Palmdale Hybrid Power PROJECT

Responses to CEC Data Request Set 1 (1-88)

Docket 08-AFC-9

PALMDALE HYBRID POWER PROJECT (08-AFC-09)

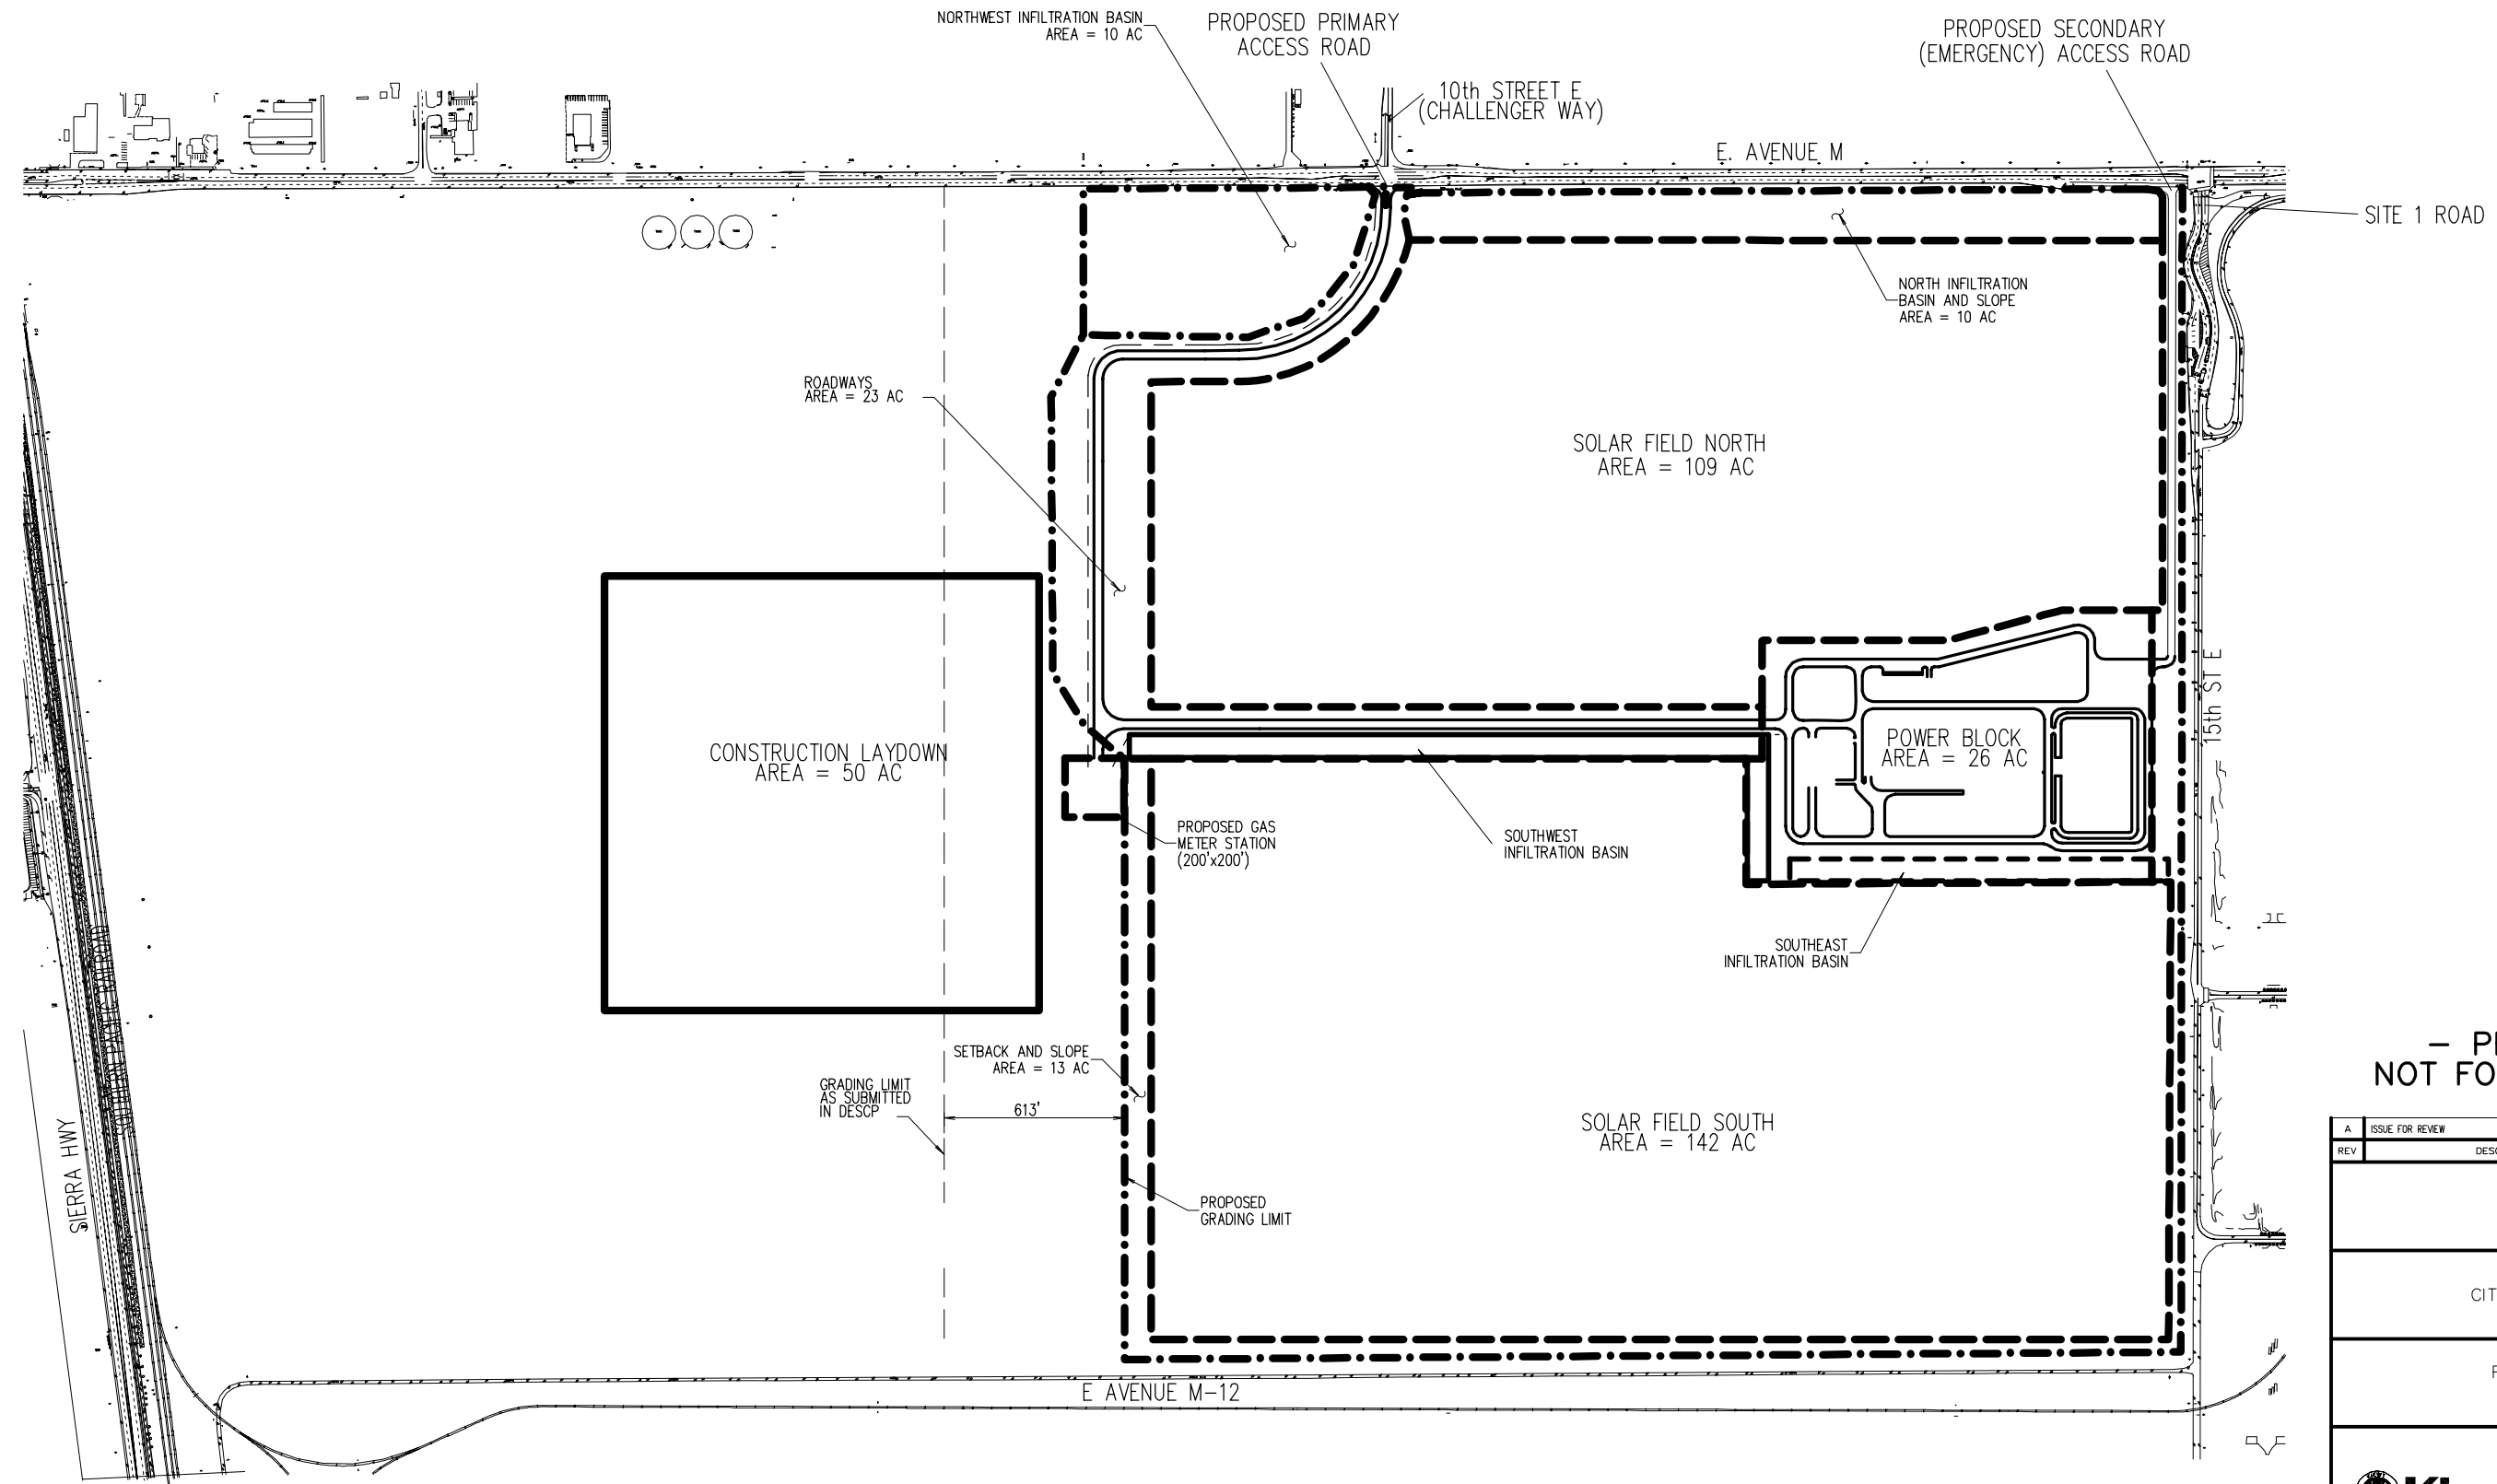
Please provide a narrative description and a map showing primary and secondary access points and gates to the project site. The secondary access point can be one restricted to the use of emergency response personnel.
